Meadows to George Street, Edinburgh

Active Travel, Footway and Carriageway Improvements

Road Safety Audit Stage 1
RSA 262/S1-A

Overseeing Organisation: City of Edinburgh Council

Problem: 4.1.1

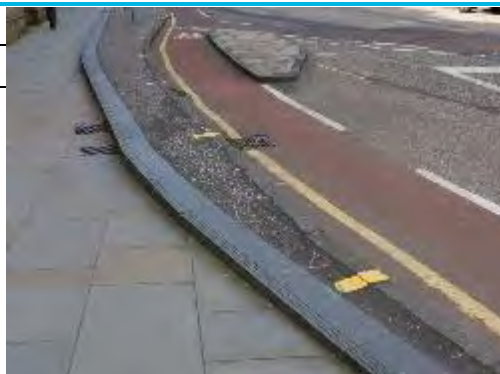
Location(s):	Scheme extents
Drawing(s):	60579473-SHT-C-0001 to 60579473-SHT-C-0007
Summary:	Risk of vehicles skidding and losing control and of pedestrians slipping and falling due to excess surface water.

From the plans provided it is unclear as to the relative levels at the interfaces between the new and existing sections of footway, and between the new sections of footway and carriageway. There is a risk that the relative levels could lead to water pooling at these interfaces. Excess surface water increases the risk of vehicles skidding and losing control and / or of pedestrians slipping and falling, particularly during periods of cold / freezing weather where the surface water could freeze and form ice.

It is recommended that appropriate drainage is provided throughout the extents of the scheme.

Problem: 4.1.2

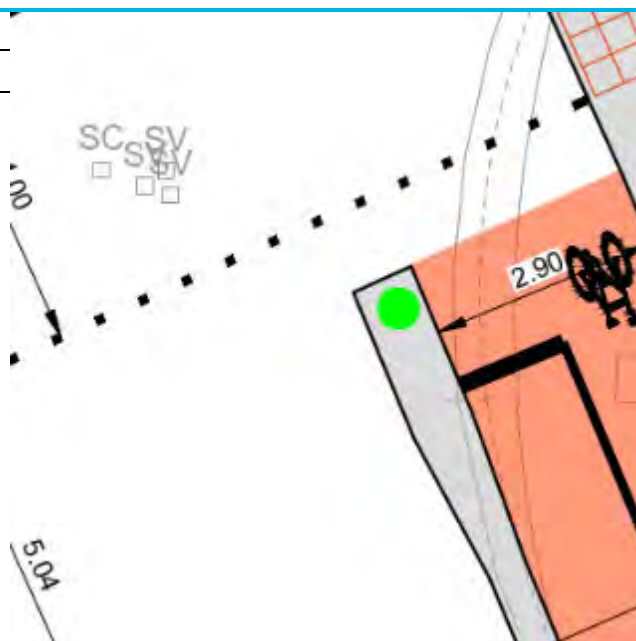
Summary: Risk that vehicles could lose control on utility covers especially in wet / damp conditions and strike pedestrians and / or street furniture resulting in personal injuries.

From the plans provided it is not clear if the existing ironwork is being raised / lowered to match the proposed surface course level and / or replaced due to being worn. There is a risk that vehicles could lose control especially in wet / damp conditions and strike pedestrians and / or street furniture resulting in personal injuries.

It is recommended that ironwork is raised / lowered and / or replaced to match the proposed surface course level.

Problem: 4.1.5

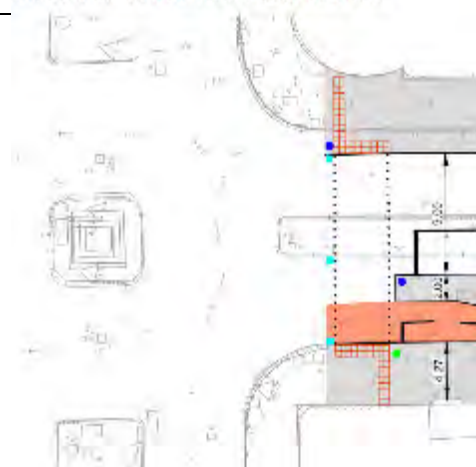
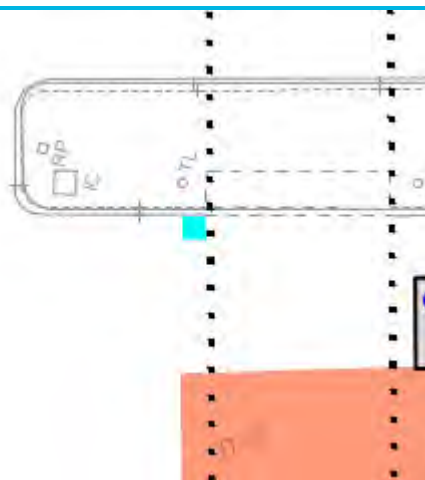
Summary: Risk of vehicles mounting the kerb, resulting in collision with pedestrians and / or street furniture.

From the plans provided, the proposals do not appear to tie into neighbouring infrastructure. Therefore, as designed, the footway will extend into the carriageway. There is a risk that vehicles will mount the footway and collide with pedestrians and / or street furniture

It is recommended that the scheme suitably ties into the neighbouring infrastructure.

Problem: 4.1.8

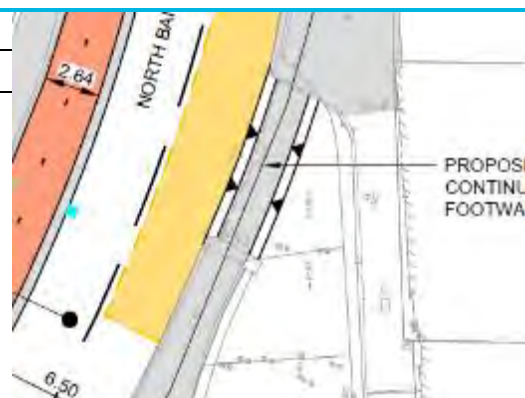
Summary: Risk during wet/damp conditions that motorised road users when braking will have insufficient grip and could lose control resulting in personal injury

It was observed during the site visit that the junction is surfaced on the approach to the existing stop or give way line with traditional cobbled setts. From the plans provided there was no indication if a different carriageway surfacing was being proposed. There is a risk during wet/damp conditions that motorised road users when braking will have insufficient grip and could lose control resulting in personal injury.

It is recommended that an appropriate level of grip material is provided on the approach to all stop lines.

Problem: 4.1.10

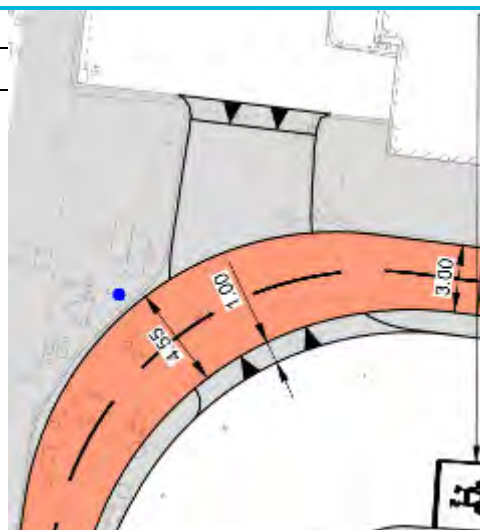
Summary: Risk of collision between vehicles and other road users due to them failing to stop or overshooting the stop line due to low grip surfacing.

It is noted that setts are used to surface the carriageway at this junction, it is unclear the relative grip available on the setts compared to standard carriageway surfacing materials. There is a risk that drivers braking on approach could skid or lose control particularly in wet conditions, resulting in potential impact with other users including pedestrians or cyclists crossing, or could collide into a queuing vehicle.

It is recommended that an appropriate level of grip material is provided on the approach to all stop lines.

Location(s): Forrest Road

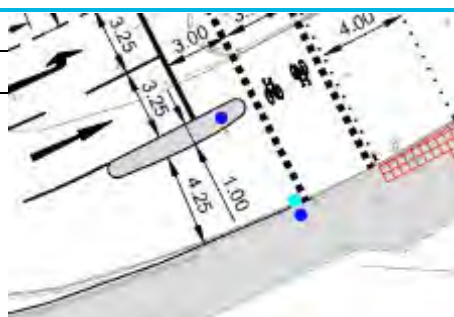
Summary: Risk of pedestrians slipping and falling, particularly during periods of cold/freezing weather due to the presence of gullies in the footways.

From the plans provided there are a number of existing gullies located within the footway as shown by the image above to the left. The existing gullies proposed to be replaced within the footway as shown by the plans, highlighted above with the image to the right. There is a risk that the relative levels could lead to surface water pooling at these interfaces. Excessive water increases the risk of pedestrians slipping and falling, particularly during periods of cold/freezing weather.

There is an additional risk that if a non-pedestrian friendly gully cover is provided; pedestrians could trip and fall leading to personal injury.

It is recommended that the levels of the footway are adequate for drainage and that a suitable gully cover is provided.

Problem: 4.2.1

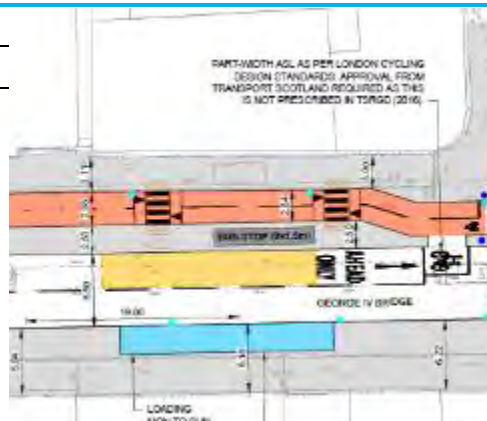
Summary: Risk of vehicles colliding with traffic signal heads.

The proposals include the provision of several traffic islands with new signal heads. An example is shown in the figure above. From the plans provided it is unclear as to what the clearance is proposed to be between the edge of the traffic signal heads and the adjacent carriageway. If the clearance is not appropriate, there is a risk that vehicles could collide with traffic signal heads.

It is recommended that an appropriate clearance is provided from the edge of each of the traffic signals heads to the carriageway.

Problem: 4.2.2

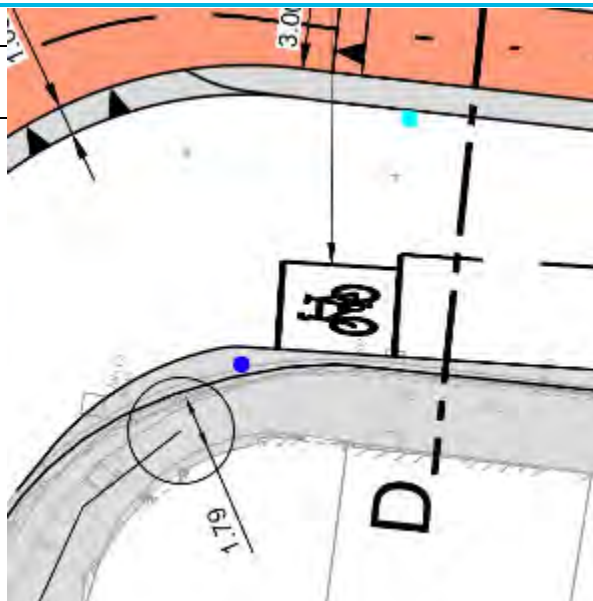
Summary: Risk that motorised road users could miss the nearside signals which may be obscured by bus shelters and / or stationary buses, resulting in collisions with pedestrians and other vehicles.

The position of the proposed bus stop and bus shelter upstream of the traffic signals is likely to restrict visibility. There is a risk that motorised road users could miss the traffic signals resulting in them driving through a red signal into conflict with pedestrians or other vehicles at the junction.

It is recommended that visibility to the nearside traffic signal head is not restricted.

Problem: 4.2.3

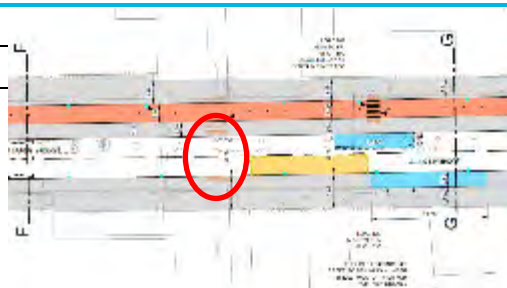
Summary: Risk of an elevated footway, guardrail and pedestrians obscuring the traffic signal, increasing the risk of drivers overshooting the stop line and potentially colliding with oncoming vehicles.

The level difference between the western footway and the carriageway of Bank Street increases as traffic approaches the stop line. The footway is estimated to be around 0.5m above the carriageway with the guardrail estimated to increase the height by 1m. Signal mounting heights are between 2.1m and 4m (TSRGD 2016), there is a risk that the signals will be mounted around the same height as pedestrians on the footway. As a result, drivers may not observe the light and continue through the junction potentially into head-on conflict with other vehicles. There is a secondary risk of loss of control resulting from sudden braking on the downhill approach upon seeing the lights late.

- Pedestrian volumes in the area are high, therefore there is a high probability that they may interfere with driver's visibility of the lights;
- The area is very cluttered with guardrail, cantilevered shop signs, built environment, queuing / congregation at shop fronts and product rails on the footway. All of which has the potential to distract visibility or reduce the conspicuity of the signals;
- The signal post appears to be located on the bend which potentially increases the impact of pedestrians and street furniture on visibility;
- Approaching drivers from George IV Bridge have limited forward visibility due to the crest at its junction with Lawnmarket, the lower elevation of the Bank Street signals and the volume of pedestrians.

In addition to the above, the relative height of pedestrians to the signal head could enable the lights to be vandalised.

It is recommended that the signal post is relocated to a position where visibility is unrestricted and the traffic lights are not impacted by pedestrians.

Problem: 4.2.5

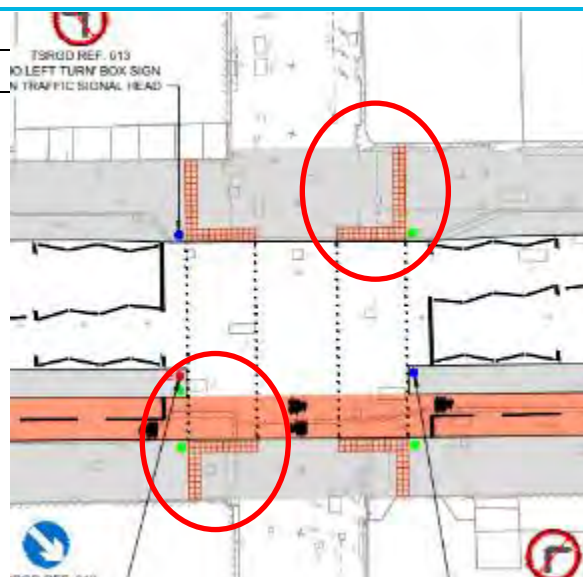
Summary: Risk that drivers braking on approach to the zebra crossing could skid or lose control resulting in them colliding with pedestrians on the crossing or into the rear of other vehicles

There is concern that drivers approaching the newly proposed zebra crossing might not appreciate the presence of the controlled crossing or potential queuing vehicles on the approach. There is a risk that drivers braking on approach could skid or lose control particularly in wet conditions resulting in potential impact with other users including pedestrians crossing or could collide into a waiting vehicle.

It is recommended that an appropriate level of grip is provided on the approach to the controlled crossing.

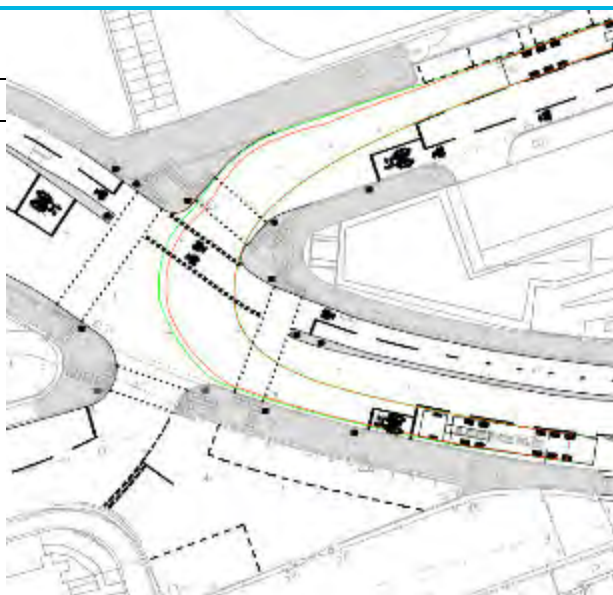
The proposals do not provide any directional signage or advance signage to inform drivers of restrictions or alternative routes. Therefore, drivers may in frustration make unsafe manoeuvres, congestion may increase and there may be an increased conflict with other road users, including pedestrians. Of particular concern is high vehicle numbers potentially being diverted onto Lawnmarket which is an area of high pedestrian movements, particularly during events such as the Fringe Festival.

It is recommended that the traffic impacts of the bus lane are fully assessed and the impacts on other junctions considered. This may require adjustments to other junctions to accommodate anticipated traffic loadings. It is also recommended that a comprehensive signing strategy is undertaken to minimise the amount of through traffic attempting to use The Mound and George IV Bridge.

Problem: 4.4.1

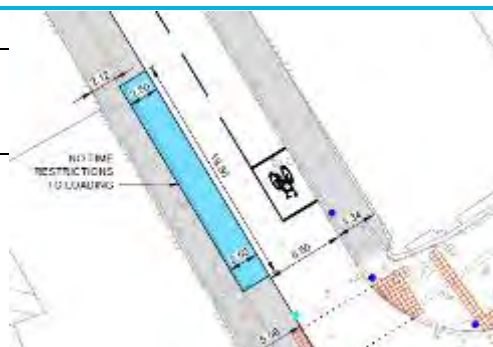
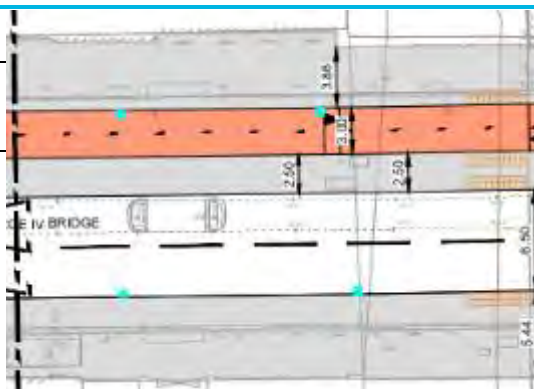
Location(s):	Flexible Loading Bays / Various Locations
Drawing(s):	60579473-SHT-C-0005, 60579473-SHT-C-0006, 60579473-SHT-C-0007 and 181203_MGS_OP_4100
Summary:	Risk that the vulnerable road users could step out into the carriageway and sustain personal injury.

From the plans provided it was observed that there are several locations where public amenities such as benches are to be located within the proposed flexible loading bays (shown in light blue above). The flexible loading bays are bounded by a single row of tactile paving; therefore, pedestrians must cross the tactile paving to access the benches. It is understood that the bay will have a limited upstand to the carriageway. No tactile paving is proposed along the carriageway edge. As a result, there is a risk that vulnerable road users, such as visually impaired pedestrians could be unaware that they are in a location open to motorised road users and could step out into the carriageway into traffic sustaining personal injury.

It is recommended that appropriate measures are provided to reduce the risk of vulnerable road users stepping out on to the carriageway.

Problem: 4.4.2

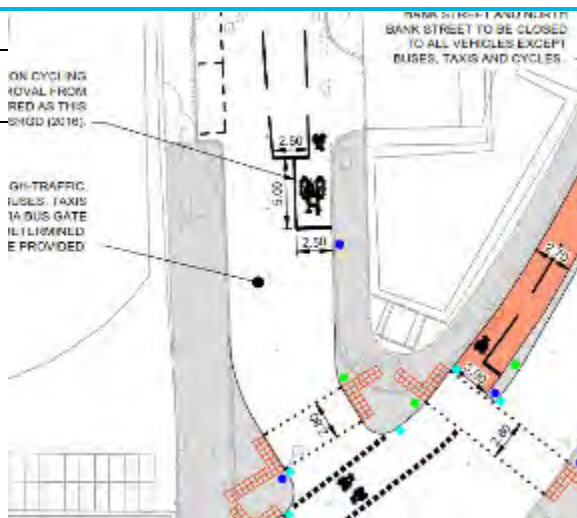
The issue could be exacerbated by the limited physical segregation. Whilst it is noted there will be a 50mm separation in levels between the footway and cycleway the chamfered kerbs would make transition between the footway and cycleway fairly easy.

It is recommended that the footway and cycleway provision is sufficiently wide to accommodate likely pedestrian and cycle flows.

Problem: 4.4.3

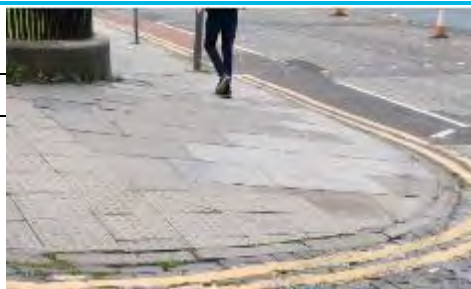
To enable vehicles to turn into Market Street the stop line has been setback approximately 20m from The Mound. An advanced stop line is provided to enable a cyclist to set off and get up to speed in front of traffic. However, due to the distance to the junction and that the cyclist will be moving off on an uphill gradient there is concern that vehicles may attempt to pass cyclists before reaching the junction. There is a risk of left hooking collisions both on Market Street where the road kinks left and during the left turn into North Bank Street. The swept path analysis for both left and right turning vehicles highlight there is limited space on the vehicles left for cyclists to be safe.

It is recommended that cyclists are provided an early start-up in the traffic signal phasing with sufficient time to reach the cycling facilities on The Mound / North Bank Street.

Problem: 4.4.4

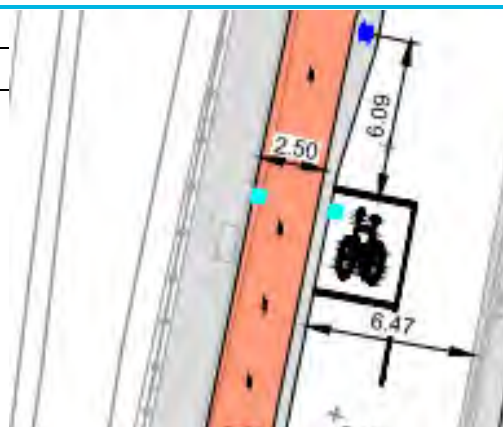
During the site investigation it was observed that there are significant gradient changes in the footway levels. An example is shown in the photograph above. There is a risk that pedestrians may slip or inadvertently step onto the slopes and fall, resulting in personal injuries.

It is recommended that the footway profile is amended to reduce the risk of pedestrians falling on a steep gradient.

Problem: 4.4.5

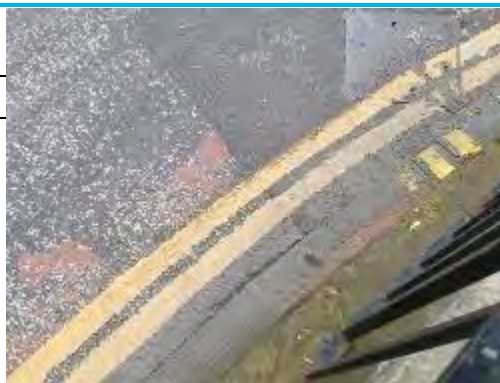
There is a secondary issue that cyclists may take to the footway to avoid other cyclists. Whilst it is noted there will be a 50mm separation in levels between the footway and cycleway the chamfered kerbs would make transition between the footway and cycleway fairly easy.

It is recommended that the cycleway is widened.

Problem: 4.4.6

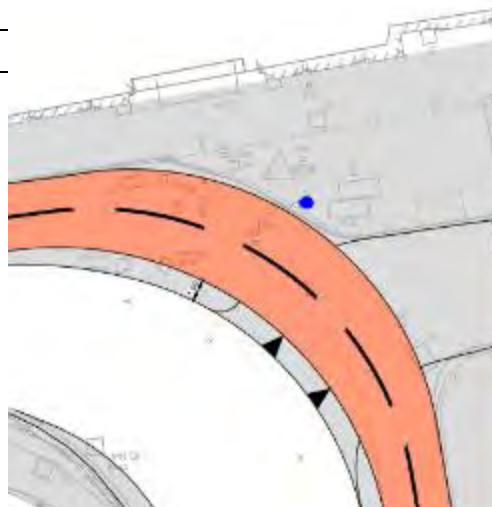
During the site investigation and from the plans provided it was observed that there are significant gradient changes in the footway levels. An example is shown in the photograph above. There is a risk that pedestrians may become trapped between the wall and motorised road users resulting in personal injury.

It is recommended that suitable measures be put in place to reduce the risk of pedestrians being trapped on the carriageway at this location.

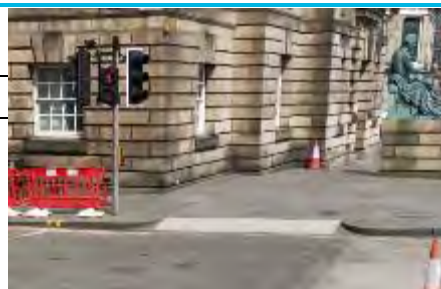
The footway is at a raised level at this location and is stepped from the carriageway, this step is situated along the footway edge. However, the proposals appear to widen the footway without removing / relocating the step. Therefore, this step potentially becomes a tripping hazard in the centre of the footway, which could lead to personal injuries.

It is recommended that the widened footway is re-profiled to remove the step..

Problem: 4.4.9

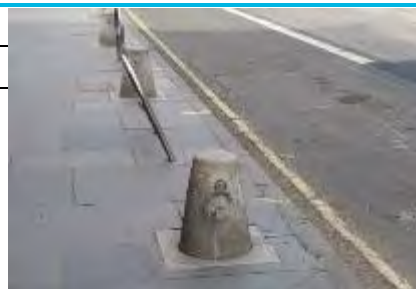
During the site investigation it was observed that the levels between the existing footway and carriageway have a gradient greater than the 8% considered acceptable for vulnerable road users. It is not clear from the proposals if the gradients will be adjusted to provide an acceptable transition between the footway and carriageway. There is a risk that pedestrians may slip and fall, especially in wet conditions resulting and personal injury.

It is recommended that suitable transitions are provided between the footway and carriageway.

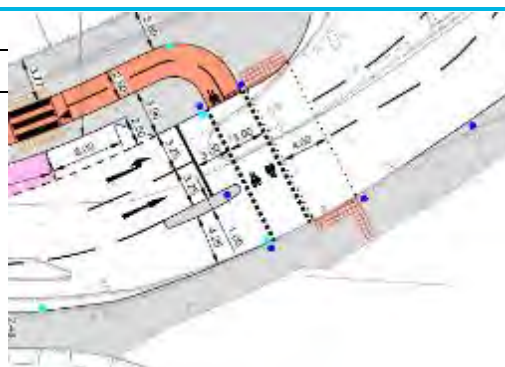
From the plans provided it was observed that there is a lack of tactile paving provided at the junction. There is a risk that visually impaired road users may not be able to determine that they have stepped onto the carriageway, sustaining personal injuries if struck by a passing motorised vehicle.

It is recommended that suitable tactile paving be provided to warn visually impaired users of the change in status of the carriageway.

Problem: 4.4.14

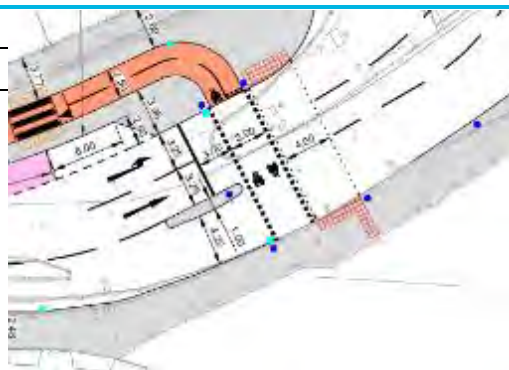
From the plans provided there is a lack of suitable tactile paving to differentiate between the shared use and pedestrian only parts of the footway. There is a risk that pedestrians and cyclists will be in-conflict and could increase the risk of personal injury being sustained.

It is recommended that suitable tactile paving be provided to differentiate between the change of status of the footway.

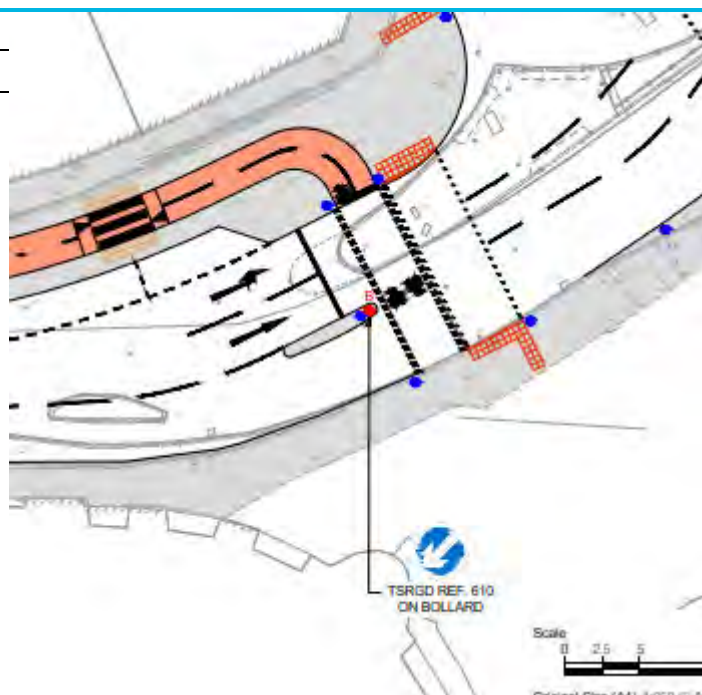
From the plans provided it is shown that there are several segregated cycle lanes that are separated from the carriageway by delineation strip formed by precast concrete kerbs.

Motorised users and cyclists could fail to notice the delineation strip during the hours of darkness and adverse weather conditions with an increased risk of sideswipe and loss of control collisions by manoeuvres to avoid the kerbs.

It is recommended that an appropriate feature is in place to highlight kerbed delineation.

Problem: 4.5.2

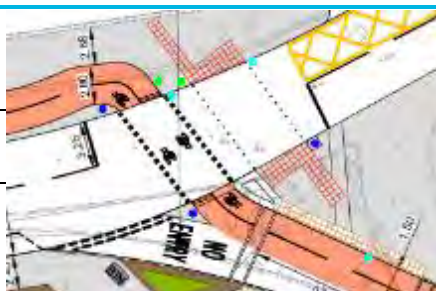
A keep left bollard is proposed on the traffic island but is located away from its leading edge, therefore its effect is reduced. There remains a risk that a driver may not be aware of the islands leading edge, potentially resulting in collision and loss of control.

It is recommended that the bollard is relocated towards the leading edge of the island, within acceptable parameters.

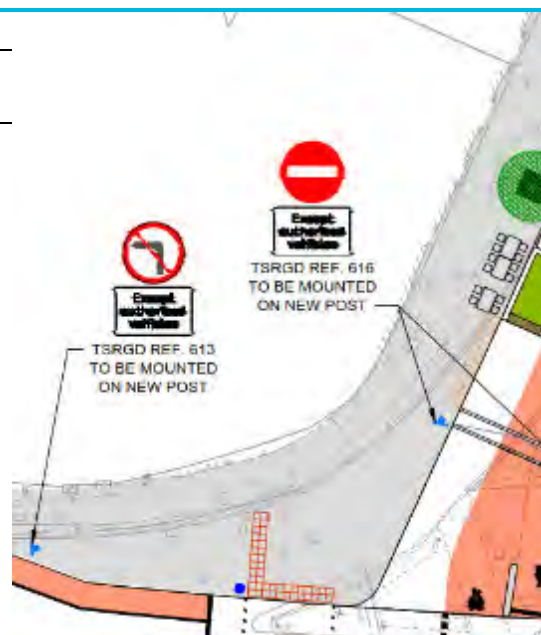
From the plans provided the lane destination arrow markings on the approach to the traffic signals at a number of junctions are close to the proposed stop lines, with no advanced signage. There is a risk that motorised road users may make sudden manoeuvres on seeing the arrows, increasing the risk of side swipe and rear end shunt collisions.

It is recommended that appropriate signage / markings are provided in advance of these locations.
